FAX Cover Sheet

| Re: CALLHAM EAST PILE | | | |

| | | | | CALLIHAM MINE MINE WASTE PILE RECLAMATION PLAN PLAN VIEW | | | |

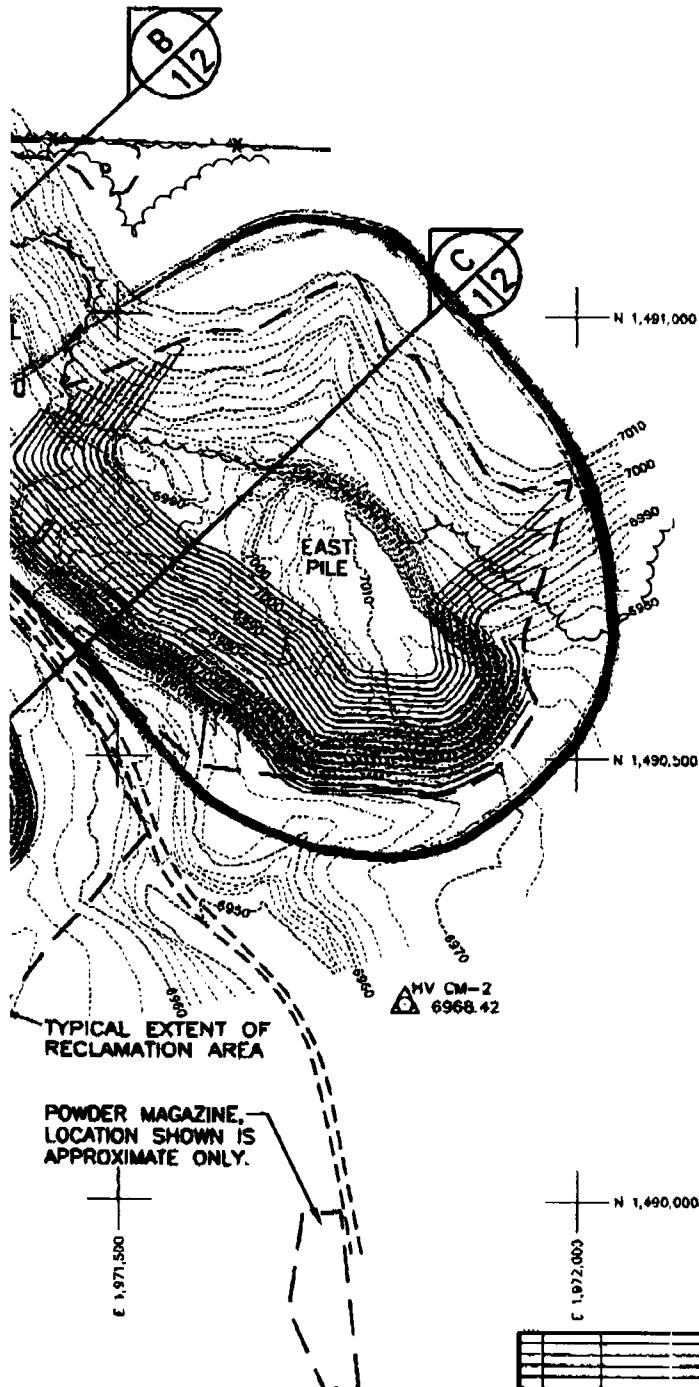
TONY - AS WE DISCUSSED ON THE PHONE - THE EAST
PILE WILL BE PUSHED TO THE NORTH ~~EST~~ TO ALLOW
FOR RECONTOURING -
